BF-3 Tube Replacement

Neutron "Remball" Detectors: Replacing BF3 Tubes with 3He Tubes

Tube Replacement Part Number: 01-5793

DWG DATE	CHK DATE	APP DATE
PW 10/30/06		
DWG NUM: 4005-023	SCALE: FULL	<input checked="" type="checkbox"/> FULL <input type="checkbox"/> OTHER
TITLE M 42-31 BF3 TUBE REMOVAL		
LUDLUM MEASUREMENTS, INC. 501 OAK STREET SHELVATER, TEXAS 75956		SHEET 17B

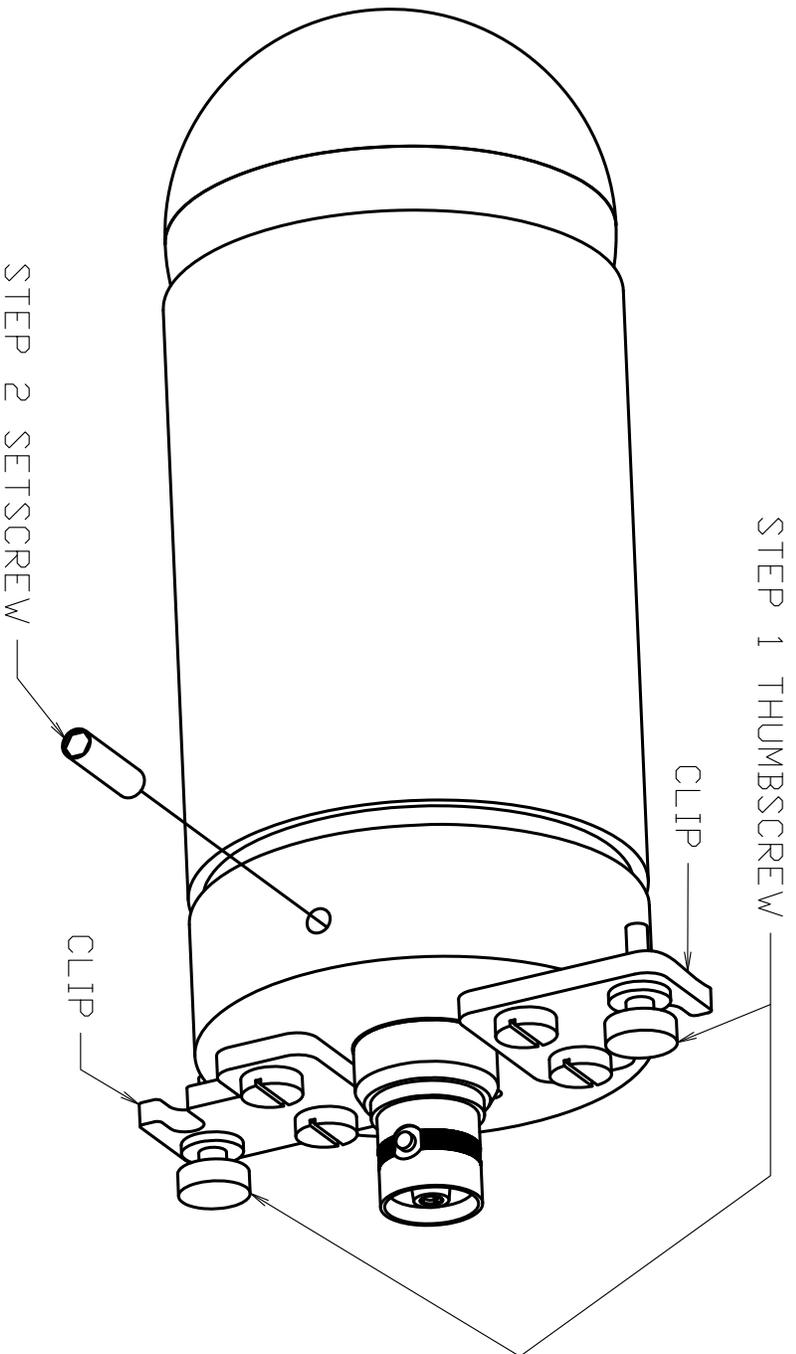
STEP 1-REMOVE THIS SECTION FROM THE POLYETHYLENE BALL BY REMOVING THE TWO THUMBSCREWS AND PULLING THIS SECTION OUT BY THE CLIPS.
 STEP 2-REMOVE THE SETSCREW FROM THE SIDE WITH A 1/8" ALLEN HEX WRENCH.

DWG DATE	CHK DATE	APP DATE
PW 10/30/06		
DWG NUM: 4005-023	SCALE: FULL	OTHER
TITLE M 42-31 TUBE REMOVAL		
LUDLUM MEASUREMENTS, INC. 501 DK STREET SHELVATER, TEXAS 75956		SHEET 17C

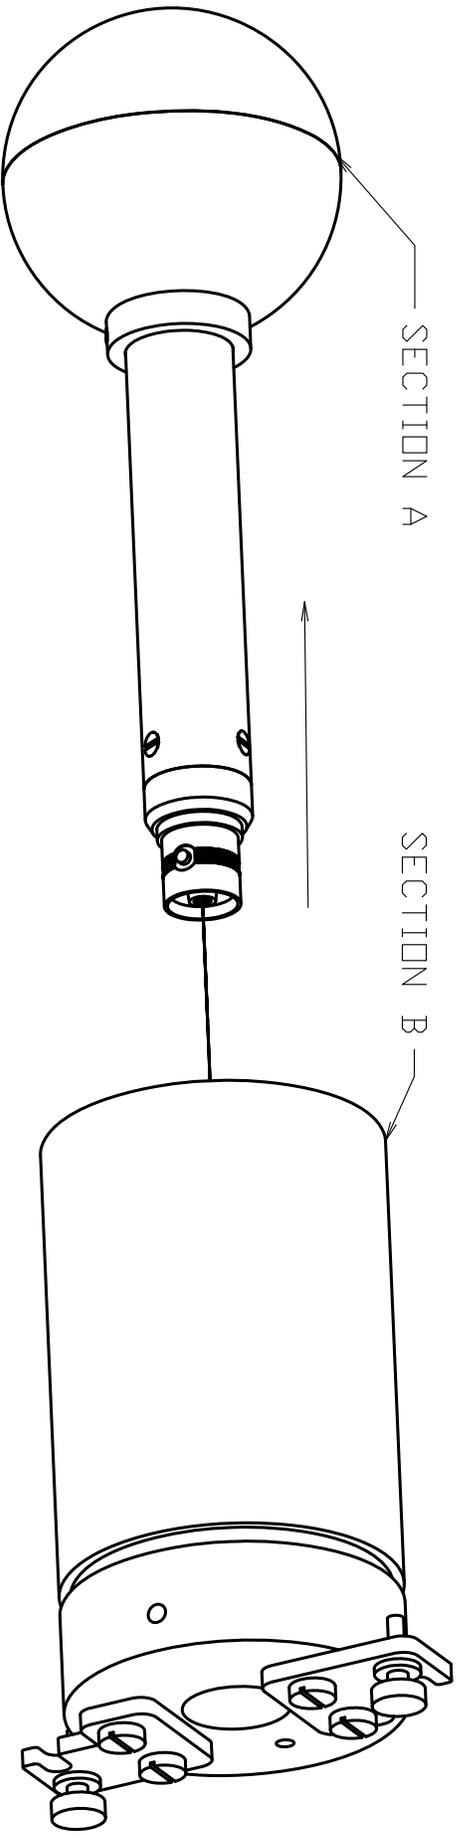
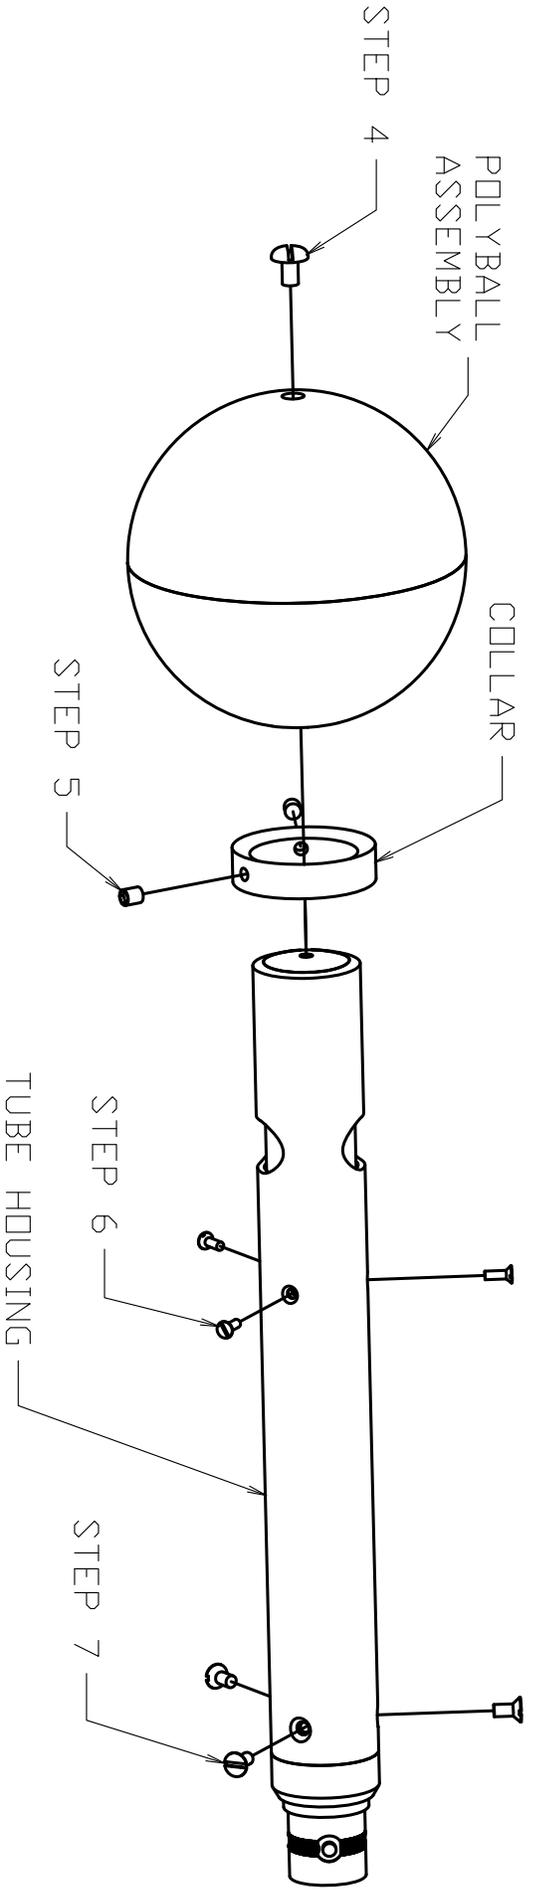
STEP 3-REMOVE SECTION A FROM SECTION B.

- STEP 4-REMOVE SCREW FROM END OF POLYBALL ASSEMBLY AND REMOVE POLYBALL ASSEMBLY.
- STEP 5-REMOVE SETSCREWS FROM THE COLLAR USING A 1/16 ALLEN HEX WRENCH AND REMOVE COLLAR.
- STEP 6-REMOVE 2-56 SCREWS (3 EA.) FROM TUBE HOUSING.
- STEP 7-REMOVE 4-40 SCREWS (3 EA.) FROM TUBE HOUSING.

DWG DATE	CHK DATE	APP DATE
PW 10/30/06		
DWG NUM: 4005-023	SCALE: FULL	OTHER <input checked="" type="checkbox"/>
TITLE M 42-31 TUBE REMOVAL		
LUDLUM MEASUREMENTS, INC. 501 OAK STREET SWEETWATER, TEXAS 79556		SHEET 17D

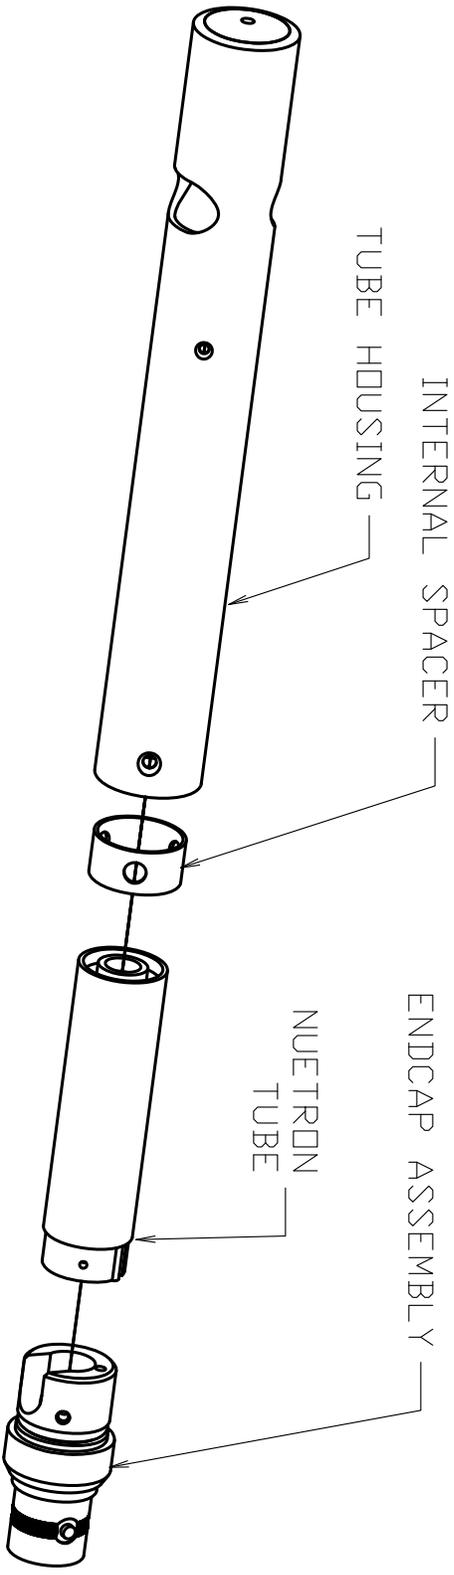
- STEP 8-REMOVE ENDCAP ASSEMBLY, NEUTRON TUBE AND INTERNAL SPACER FROM TUBE HOUSING.
 - STEP 9-UNWELD THE WIRES FROM NEUTRON TUBE AND DISPOSE OF NEUTRON TUBE PER LOCAL, STATE AND FEDERAL REGULATIONS.
 - STEP 10-REASSEMBLE THE DETECTOR WITHOUT THE NEUTRON TUBE IN REVERSE ORDER AND SHIP THE MODEL 42-31 WITH THE MODEL 12-4 BACK TO
 LUDLUM MEASUREMENTS INC.
 ATTN: REPAIR DEPARTMENT
 501 OAK ST.
 SWEETWATER TX 79556
- *
 ND RMA NUMBER IS NEEDED BUT A NOTE WITH A CONTACT NAME AND PHONE NUMBER IS.
